**PRELIMINARY DRAINAGE REPORT
FOR
SCHMIDT PARCEL **EARLY GRADING** AN**

**May 2022
Project No. 25188.13**

CDR-22-007

DETENTION BASIN STAGE-STORAGE TABLE BUILDER

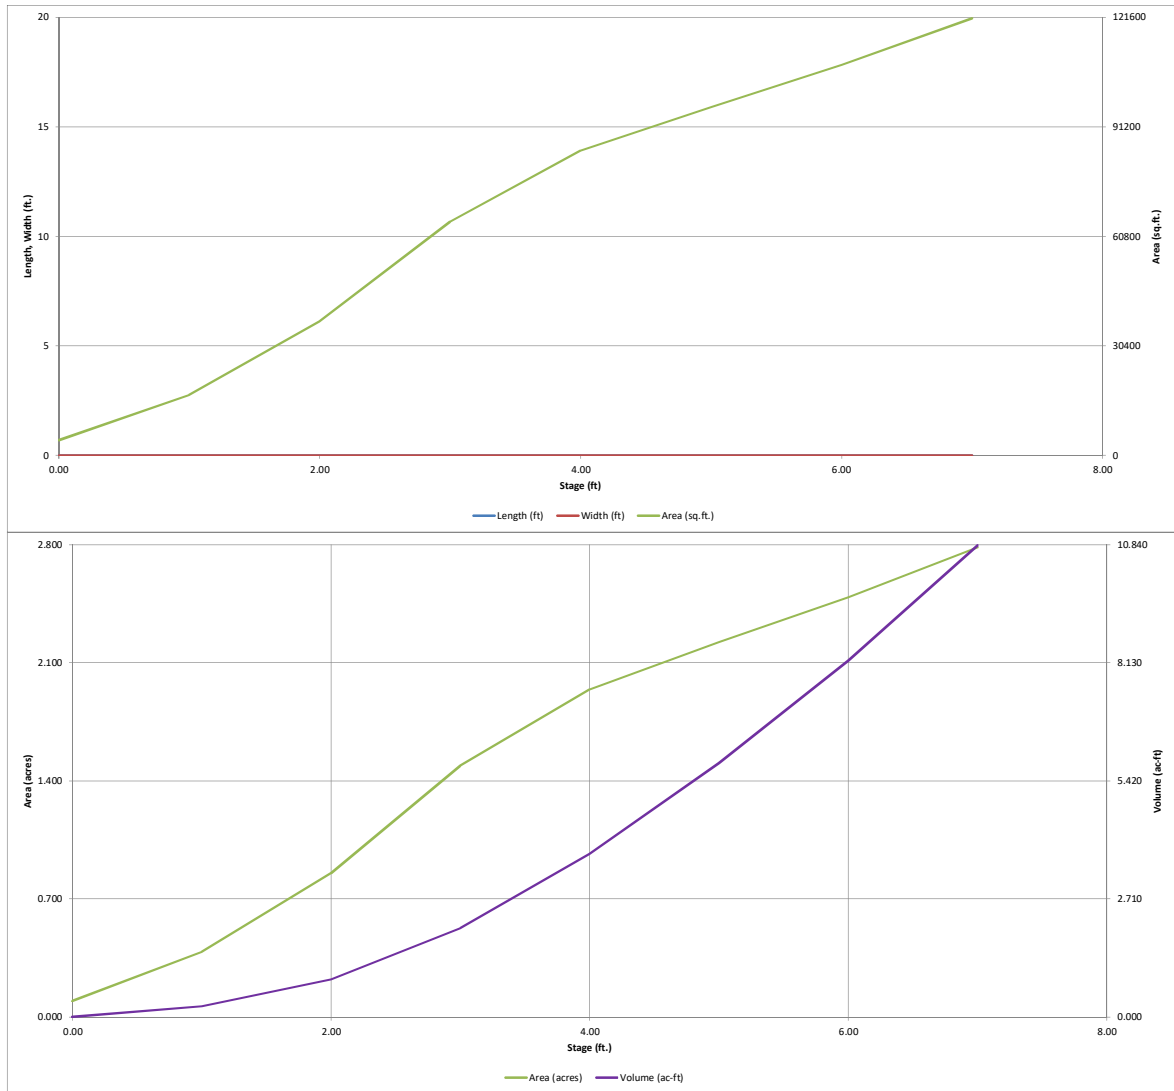
should have
r drain time

EXISTING DRAINAGE MAP
SCHMIDT PARCEL
JOB NO. 25188.13
05/03/2022
SHEET 1 OF 1

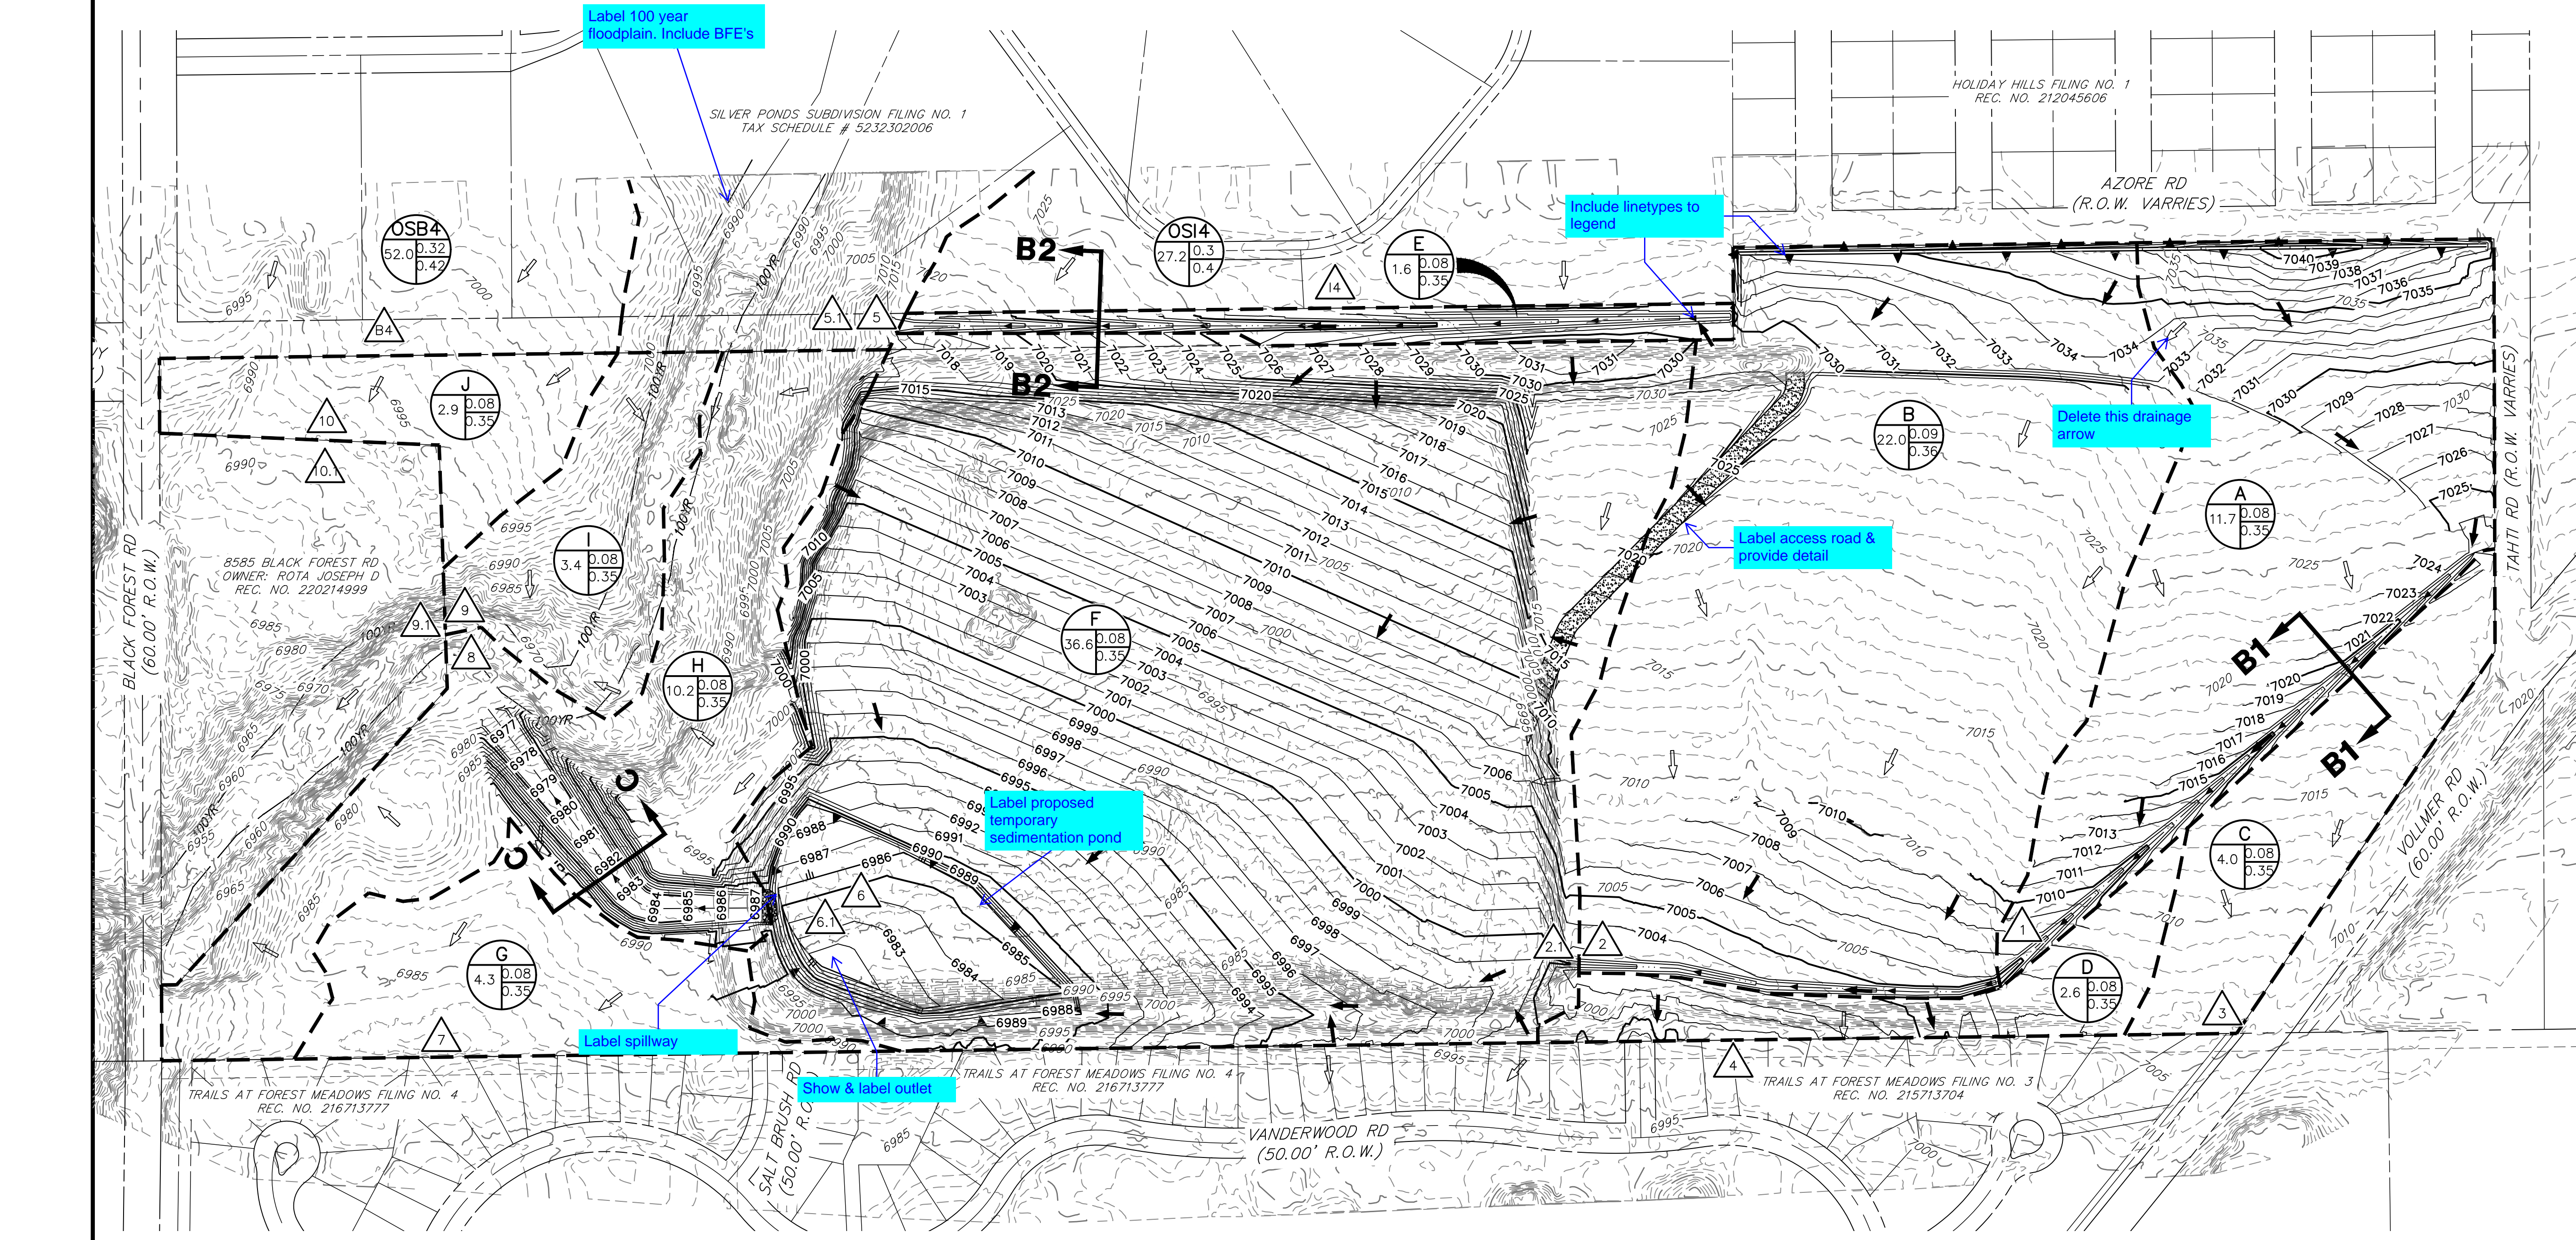
Add OS14 & OSB4 to table

- Show boundary between Sand Creek & Cottonwood Creek Drainage basins
- Show & label property boundary

PROPOSED DRAINAGE MAP
SCHMIDT PARCEL
JOB NO. 25188.13
05/09/2022
SHEET 1 OF 1

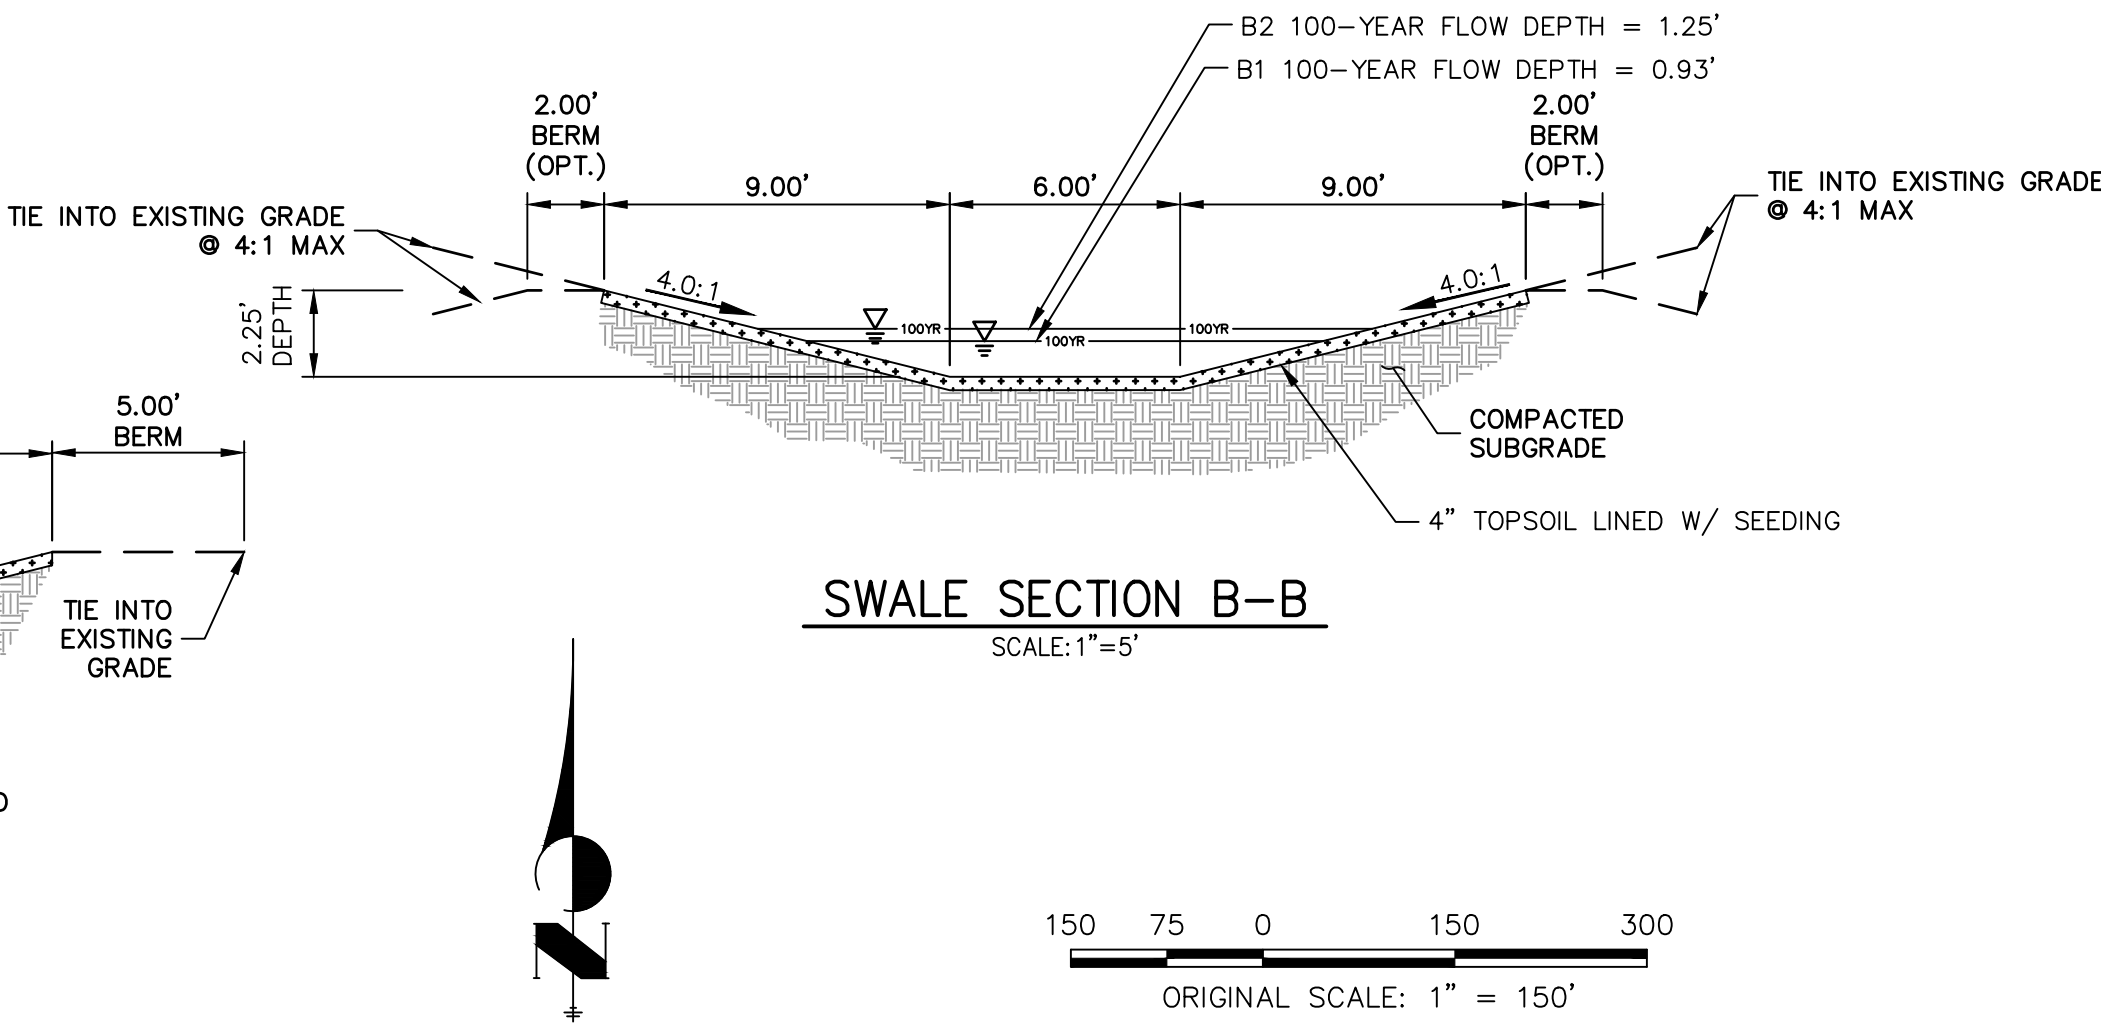
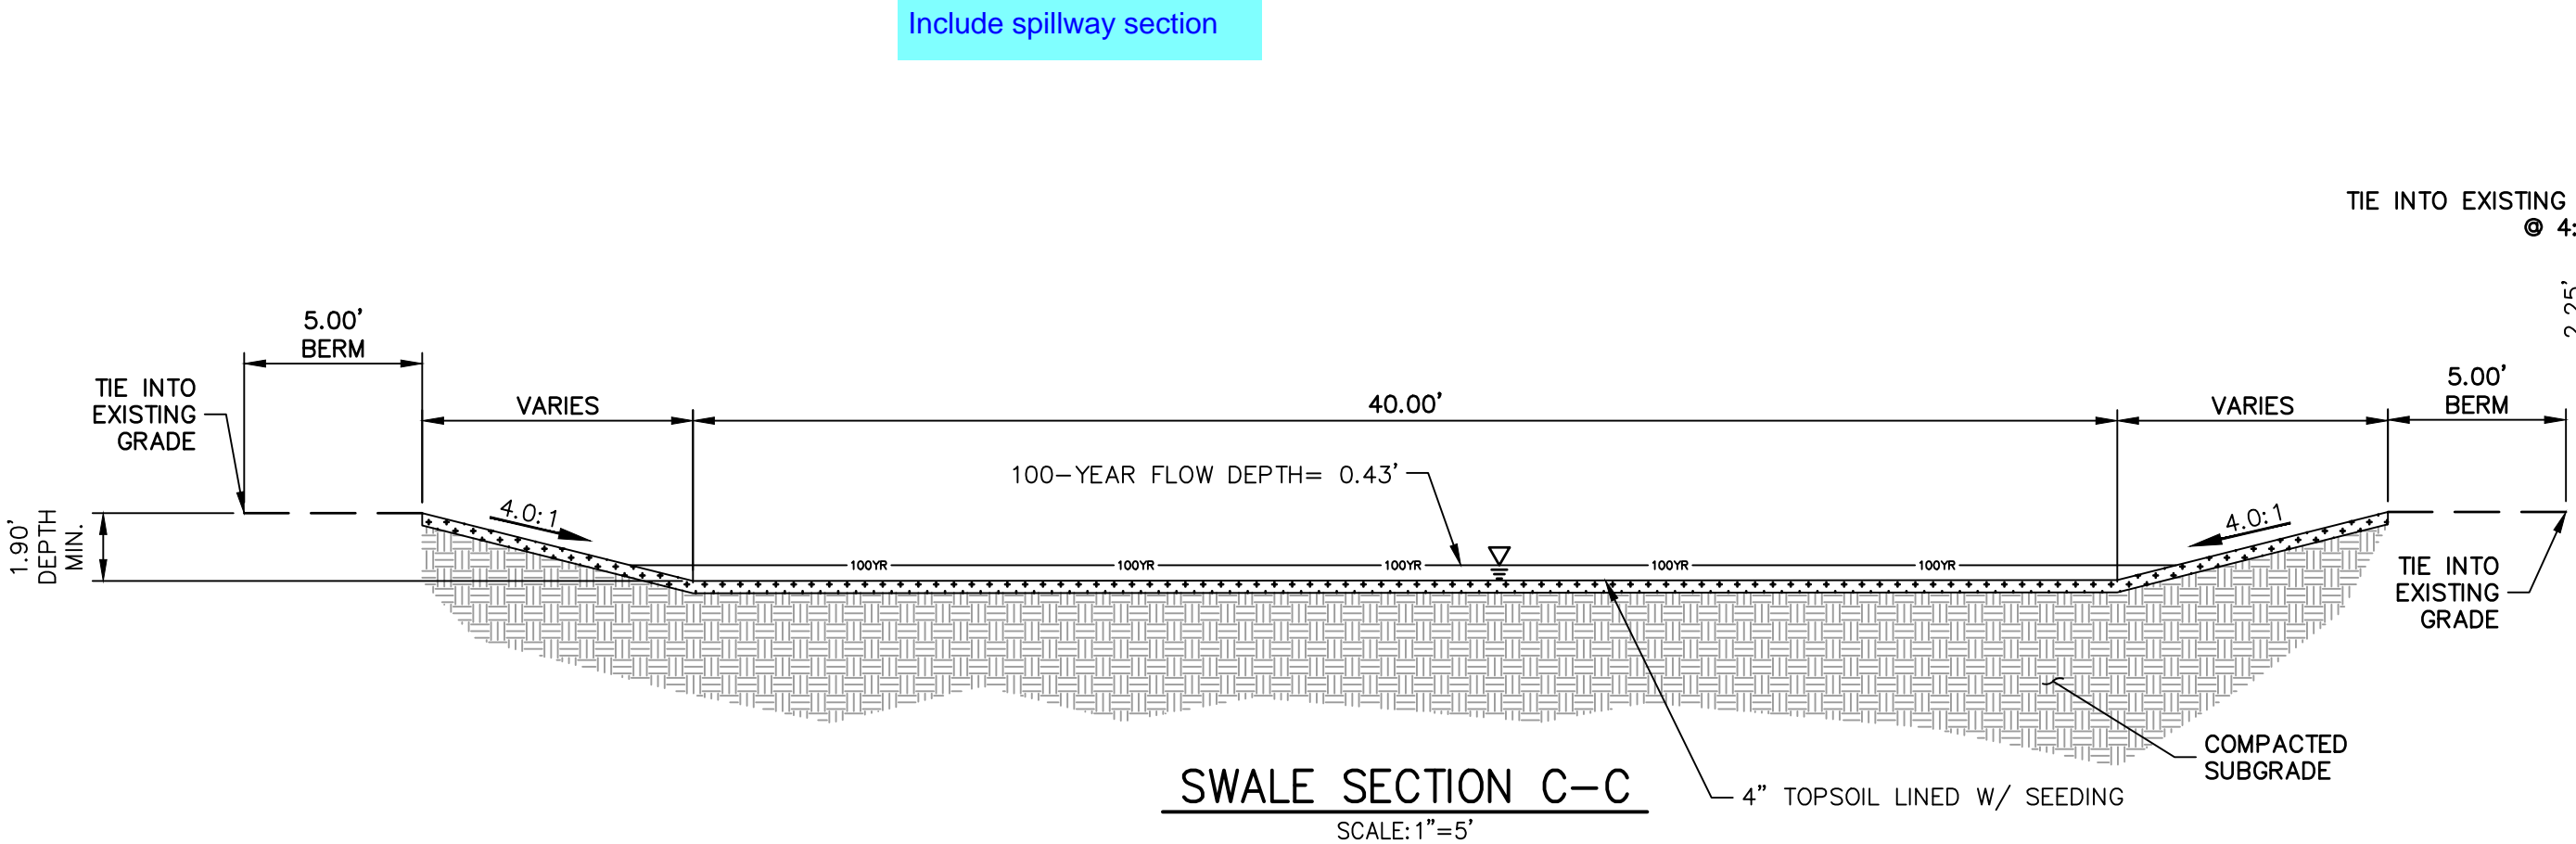
Add OS14 & OS B4 to table

Match linetype in plan
